SUBJECT: WATTS BAR NUCLEAR PLANT - NSRS REPORT R-80-21-WBN

NSRS Report No. R-80-21-WBN

Subject: Review of the WBN CONST Project Program Governing the  
Installation and Inspection of Safety-Related Piping and  
Supports

FIGURE 2.0  
 CAUSE/EFFECT CHART FOR  
 PIPE HANGER INSTALLATION  
 PROBLEMS

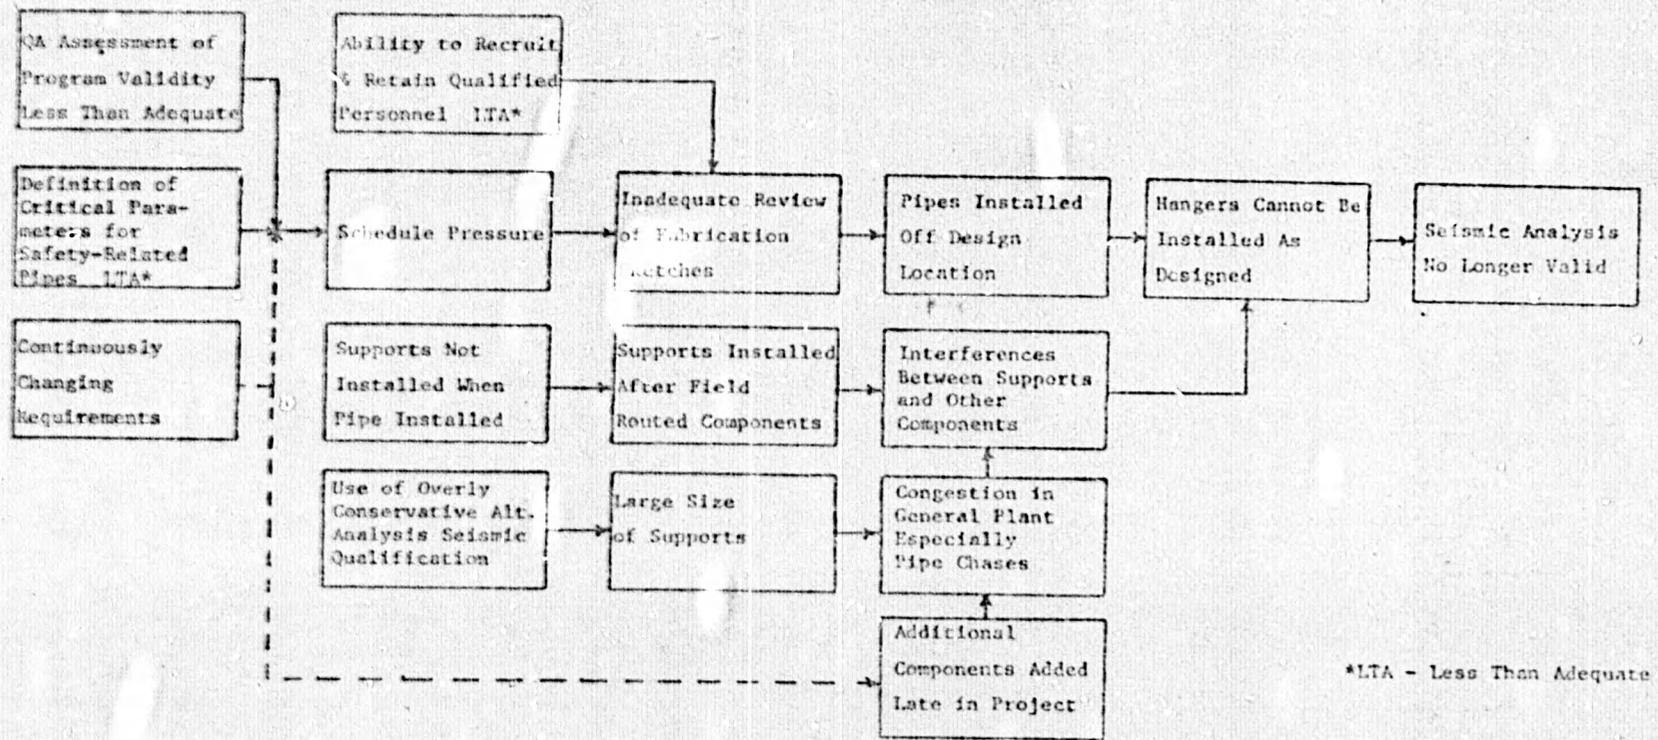
- ⊖ This mislocated piping coupled with congestion caused by the installation of field routed (located) structures, systems, and components has made hanger installation per the original design difficult, if not impossible, to achieve.

- A problem was encountered in obtaining the permanent hangers and supports in a time frame consistent with the installation of the safety-related piping. Consequently, the permanent piping was installed on temporary hangers. These factors in and of themselves did not create a problem. However, installation of field routed (located) structures, systems, and components too close to the piping to allow installation of the permanent piping and supports transpired. This has and is causing difficulties with the installation of permanent supports.

- Use of different reference points to locate piping and to locate hangers resulted in further complications. Pipe location is referenced off of column centerlines while supports and hangers are referenced off of nominal wall, ceiling or floor faces. The result in some instances is a support or hanger that totally misses the piping that it is supposed to support, even though both pipe and support are installed per their respective design requirements. This problem with the reference points needs to be resolved. (See recommendation B, Section III.)

EN DES organizations that specify locations for piping and supports at WBN should review their current practices to determine the extent of this problem. Based on the findings of the review, these organizations should specify corrective actions to eliminate this problem on present and future drawings under their control and on drawings issued to the WBN CP or already implemented by the WBN CP.

FIGURE 1.0  
 CAUSE/EFFECT CHART FOR  
 RESIDUAL PIPE STRESS

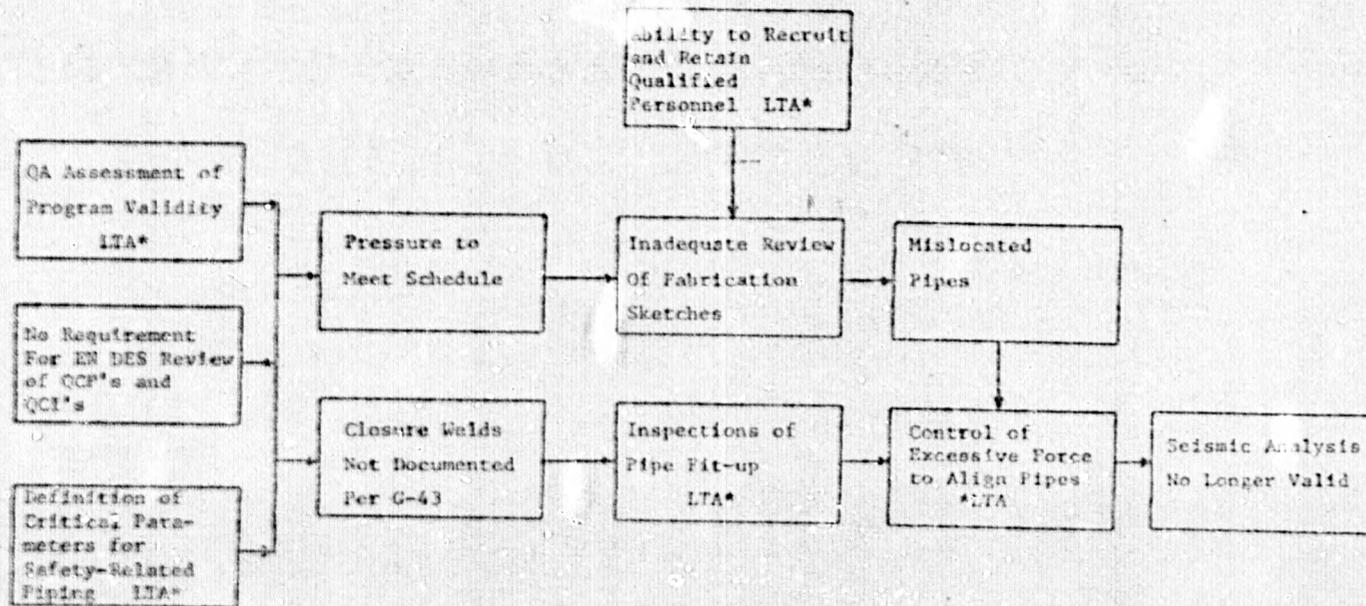
- ⊖ Varying amounts of residual stress due to the use of external force to effect weld joint alignment exists in the piping and equipment nozzles.
- ⊖ The mislocated piping, the inability to install permanent hangers and supports per design, and the existence of residual stress in piping and nozzles taken individually or as combinations have the potential to invalidate the original seismic analysis for the plant safety-related piping systems.

- c. G-43 does contain some specific requirements such as the 1/16-inch maximum allowable misalignment of pipe joints while swinging free on supports for closure connection final assembly. This specific requirement is in G-43 to prevent significant preload on the final assembly connection which is a general assumption used in the seismic analysis. The concern for minimizing preload is justified per the seismic analysis; however, this requirement does not reflect conditions achievable from a constructability standpoint or criteria which are consistent with the ASME code on weld joint misalignment and on "cold-springing." Since the ASME code is utilized more extensively than G-43 and since the weld joint fit-up inspections are performed by welding unit personnel, the requirements of G-43 in this area tend to not be vigorously followed. Consequently, a documented program to minimize pre-load due to use of external force to effect closure connection alignment was never implemented at WBN. Piping fit-up was generally checked against the requirements of the ASME code. As a result, instances of preload outside the limits allowed by G-43 and subsequently the seismic analysis may exist in nozzles and piping at WBN. The impact of this situation on the seismic analysis cannot be determined until after the extent and magnitudes of the preload are determined. The most important point is that a situation exists in the field which may indeed invalidate the seismic analysis. Consequently, this situation must be evaluated and resolved. (See recommendation A, Section III.)

CEB with the assistance of the WBN CP should assess the magnitude and frequency of the existence of preload in the piping. Based on these findings CEB should specify corrective actions, if any, to eliminate the problem and to ensure the validity of the seismic analysis. In addition changes to the existing program that are acceptable to both organizations should be identified and implemented to prevent recurrence of the problem in piping being installed now and in the future.
